**LEBANON PLANNING BOARD  
MARCH 8, 2021 - 6:30 PM  
REMOTE VIA MICROSOFT TEAMS  
LEBANONNH.GOV/LIVE**

**Agenda  
Planning Board  
March 8, 2021**

Staff Memorandum – PB2021-02-EXT – *continued from 2/8/21*

EXISTING CONDITONS & DEMOLITION PLAN FOR  
**OCCOM PATH - BASIC HOLDINGS, LLC**  
OAK RIDGE ROAD, CITY OF LEBANON, GRAFTON COUNTY, NH

LANDSCAPE & LIGHTING PLAN FOR  
OCCOM PATH - BASIC HOLDINGS, LLC  
OAK RIDGE ROAD, CITY OF LEBANON, GRAFTON COUNTY, NH

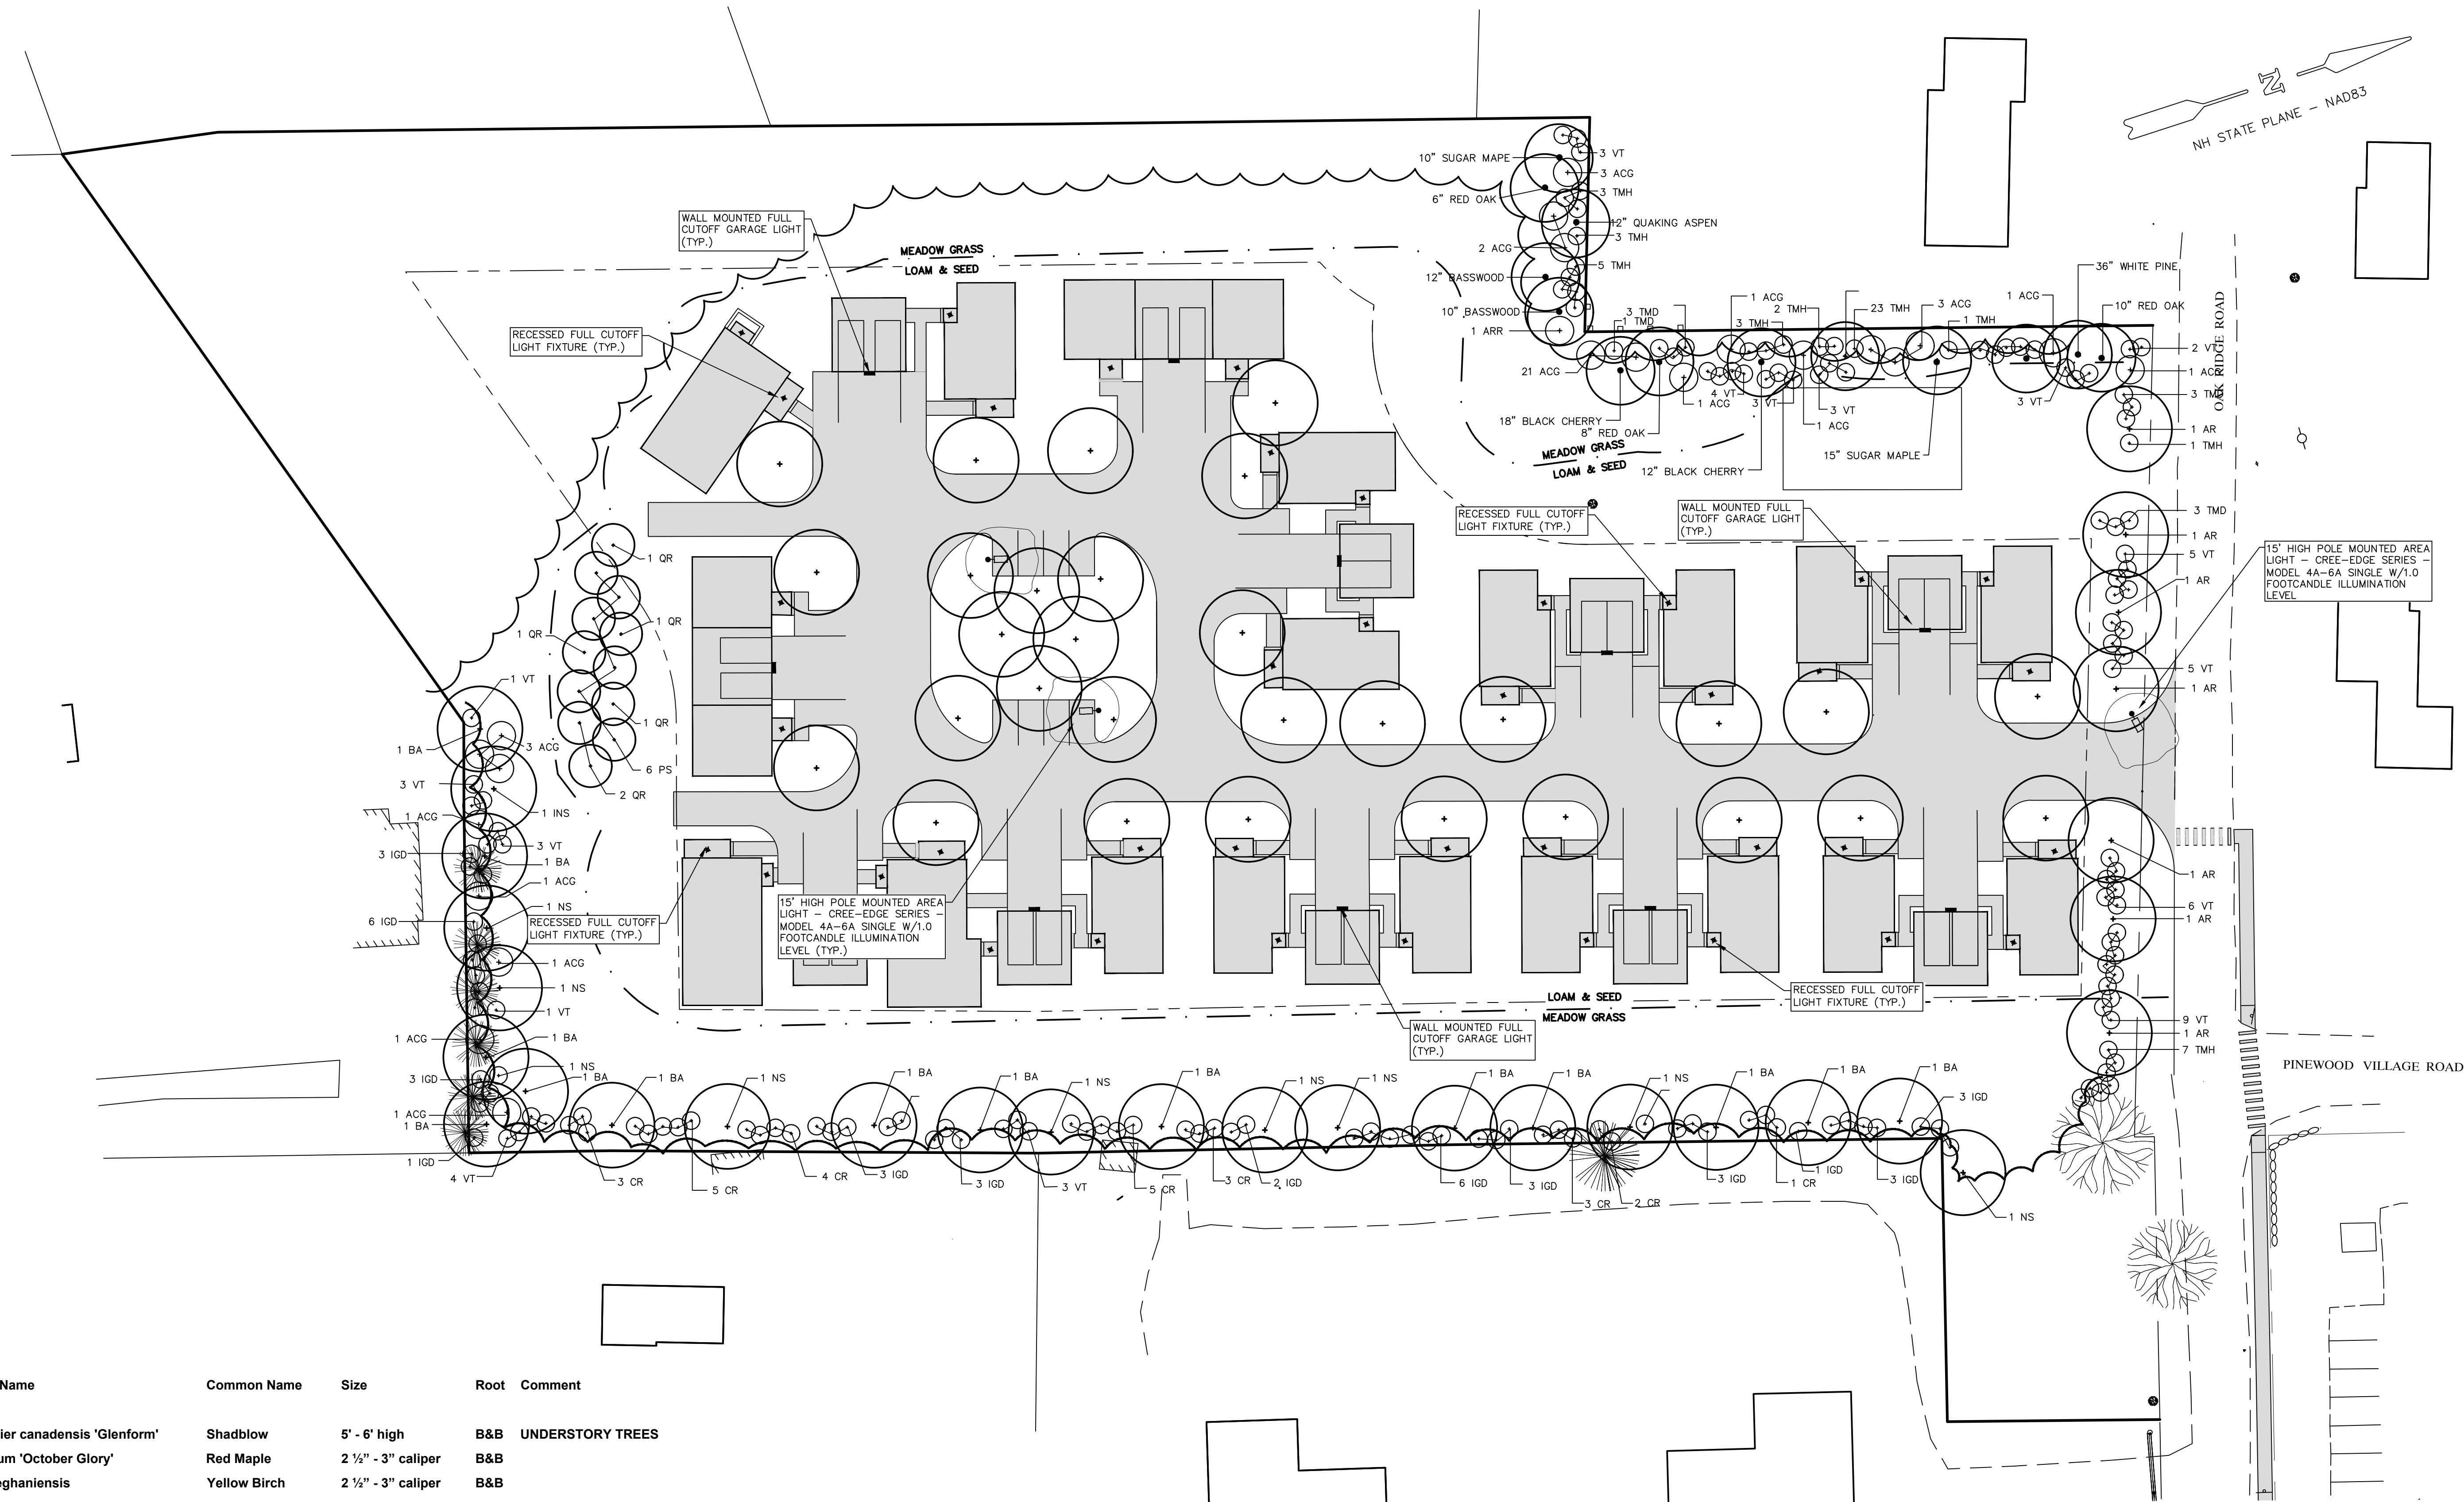
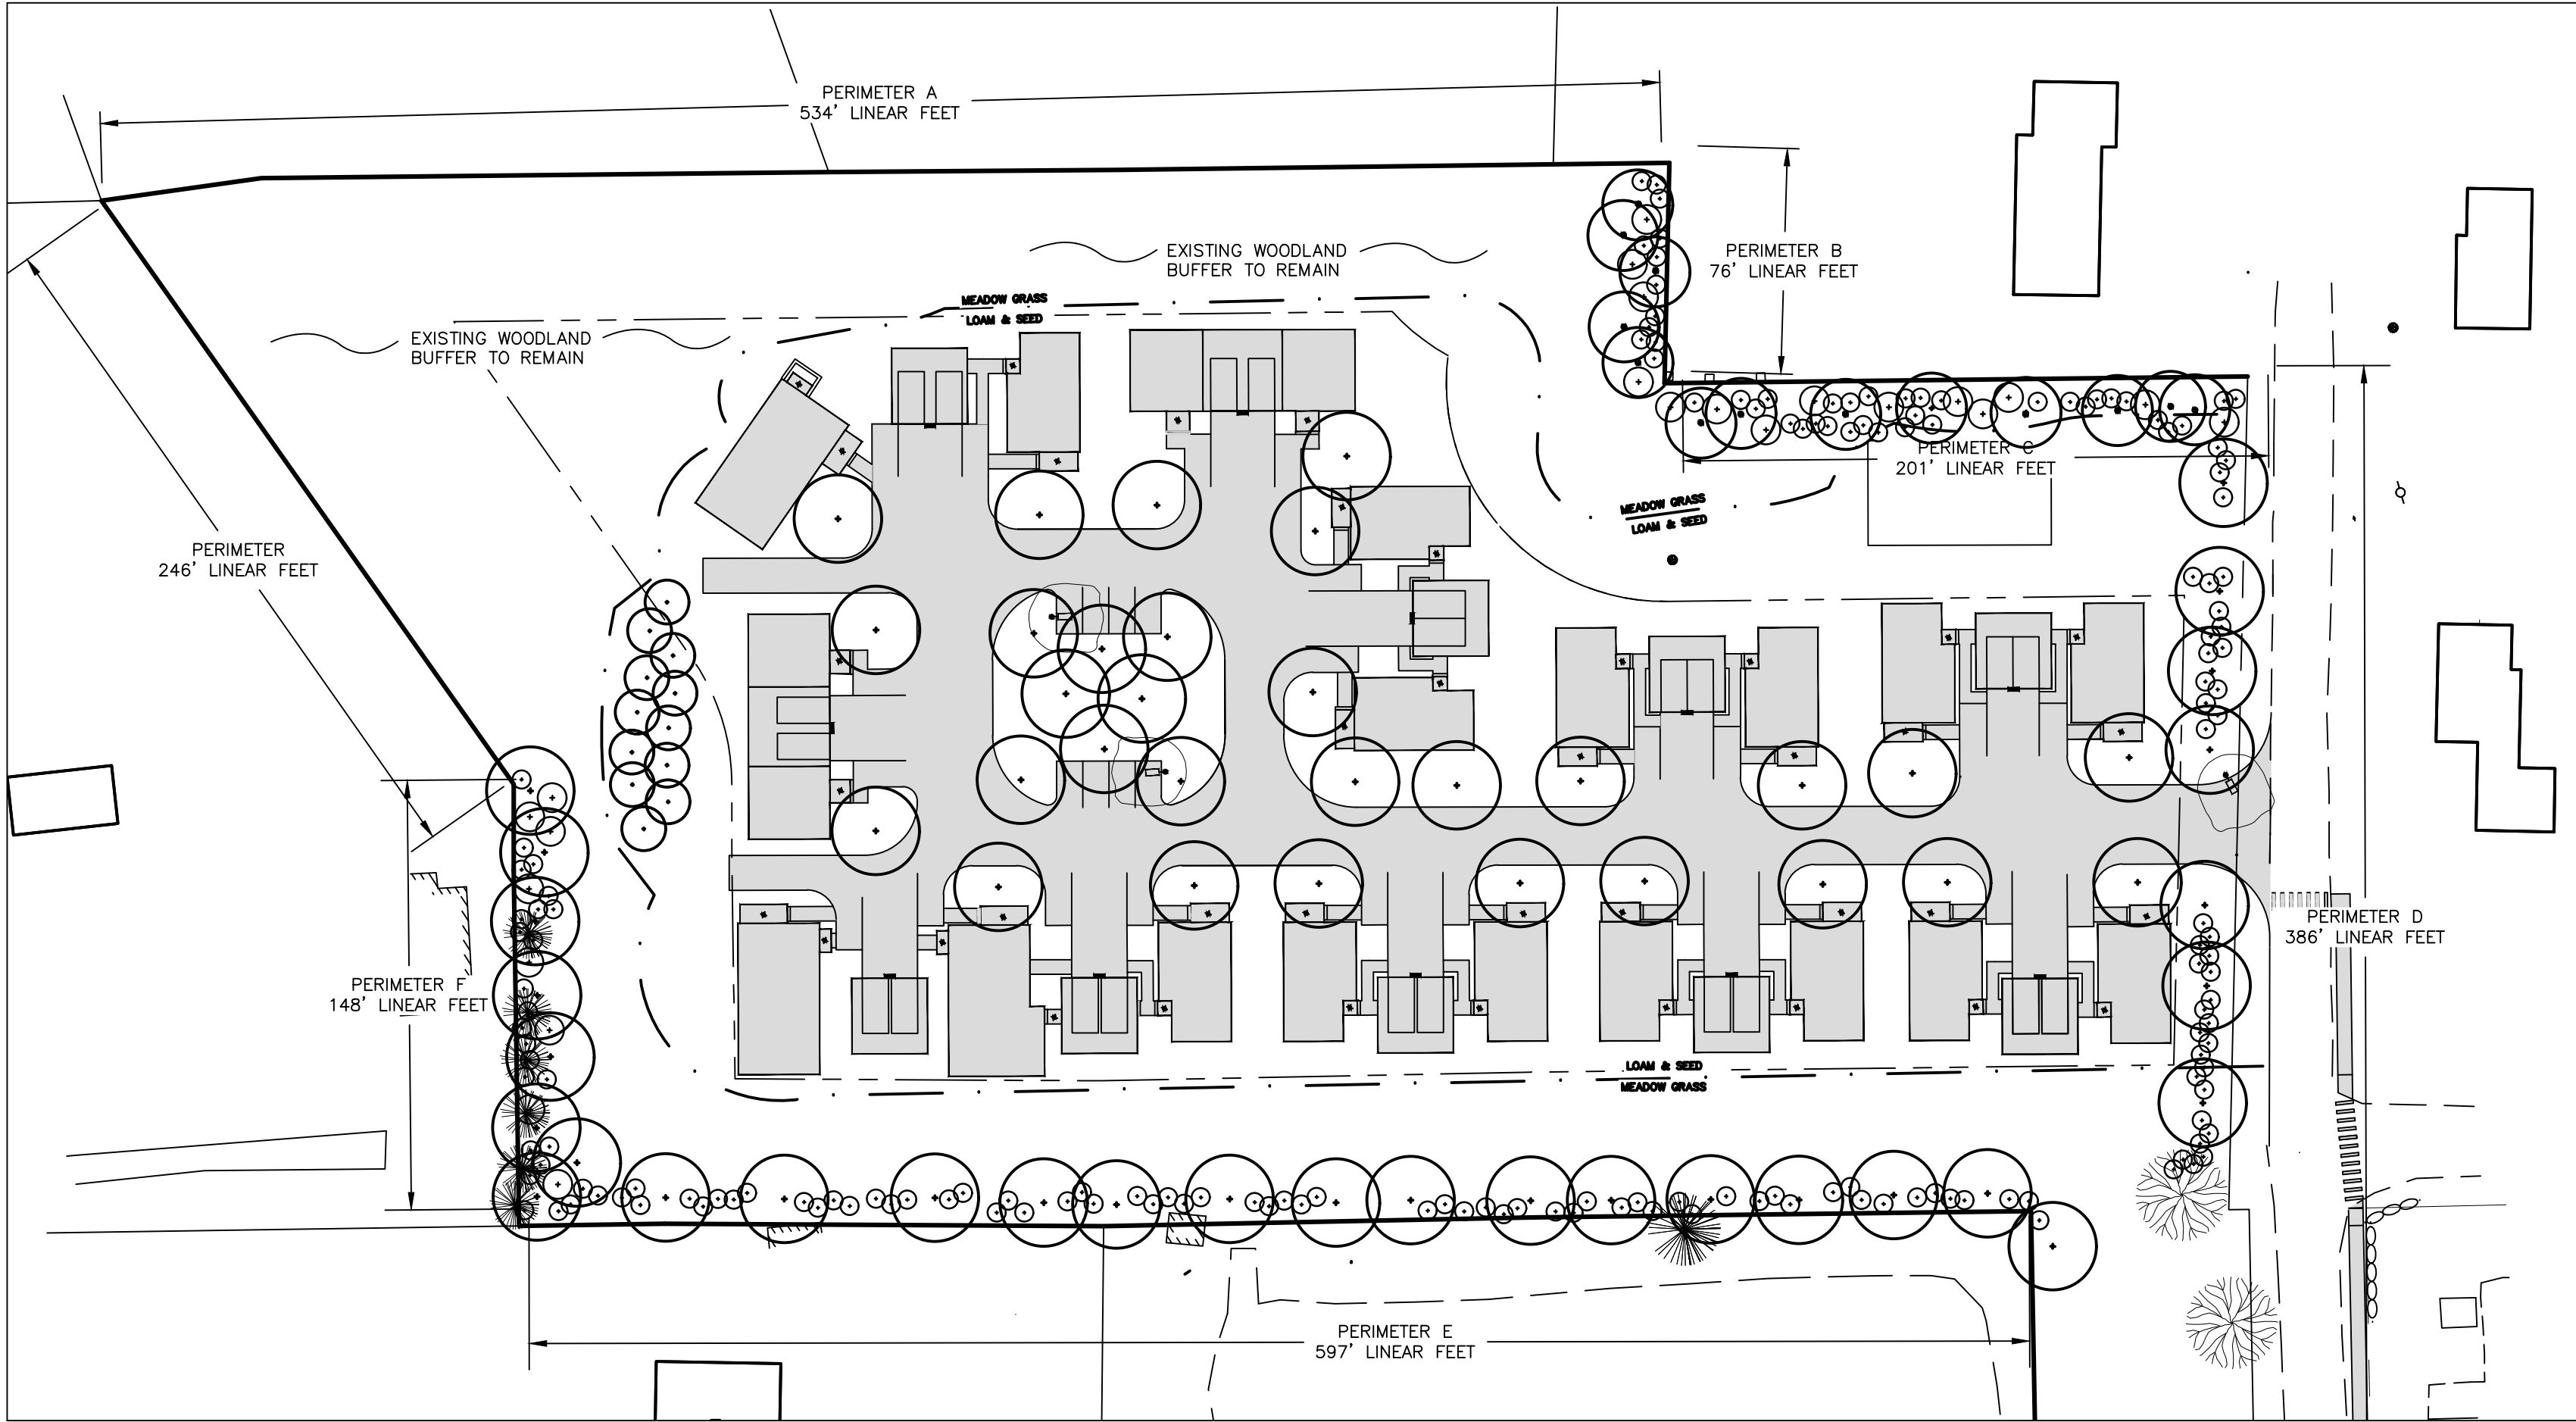
- f) On Sheet 10 (landscape & lighting plan):
    - i. Identify correct percentage of evergreen trees proposed (SPR Section 6.2.B.4)
    - ii. Identify wattage for the three pole lights (SPR Section 5.1.E.12); and
